**Date:** 11 January 2019  
**Golder Project No.:** 1893614/3000  
**Information Request No.:** EMAB-14  
**Revision No.:** Rev. 0  
**Reviewer:**  
**Topic:** Model Calibration  
**Responded By:**

*Figure 1. Original model air temperature time series vs. air temperature time series used in the Scenario 5 as a result of climate change.*

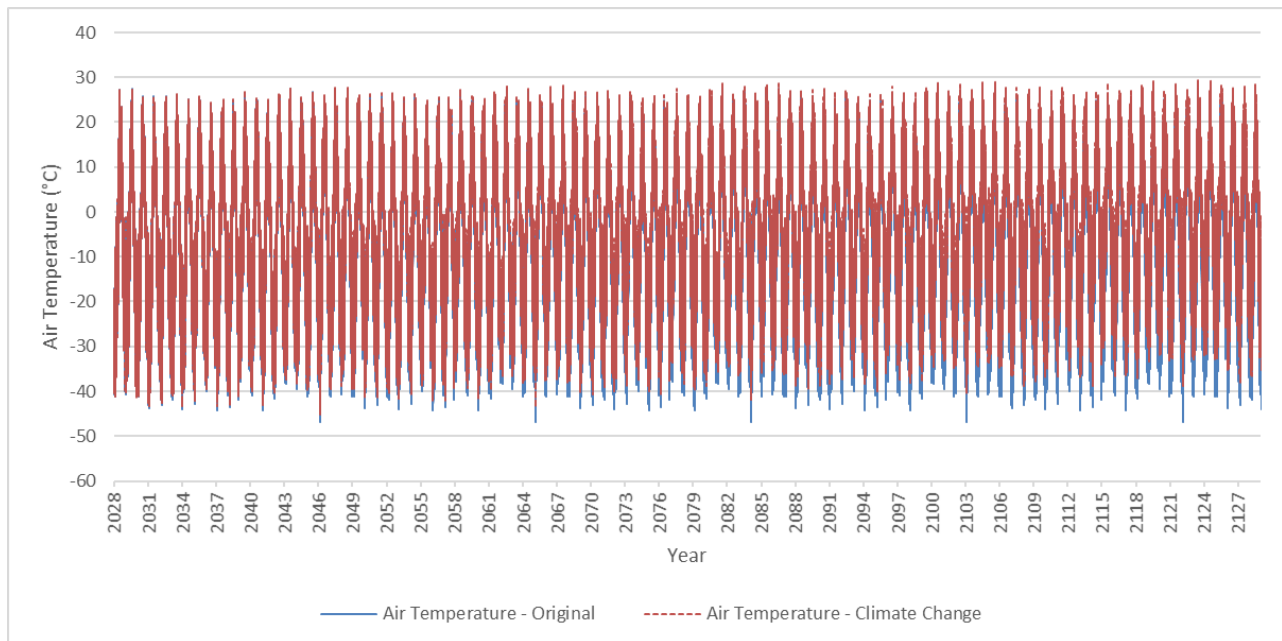
Diavik should complete sensitivity analyses for a range of potential inputs to the model (e.g. meteorological conditions, lake temperature, porewater quality, dissolved oxygen content, etc.).

This model run was completed to test the sensitivity of the model to a warming air temperature trend as a result of climate change. The original air temperature time series was developed using Diavik on-site meteorological data. Using data provided in Tetra Tech (2017), a new time series was developed whereby the annual temperature increase rate was applied. Table 3 details the annual warming rate by month, and Figure 1 shows the comparison between the original time series and the time series used in this scenario.
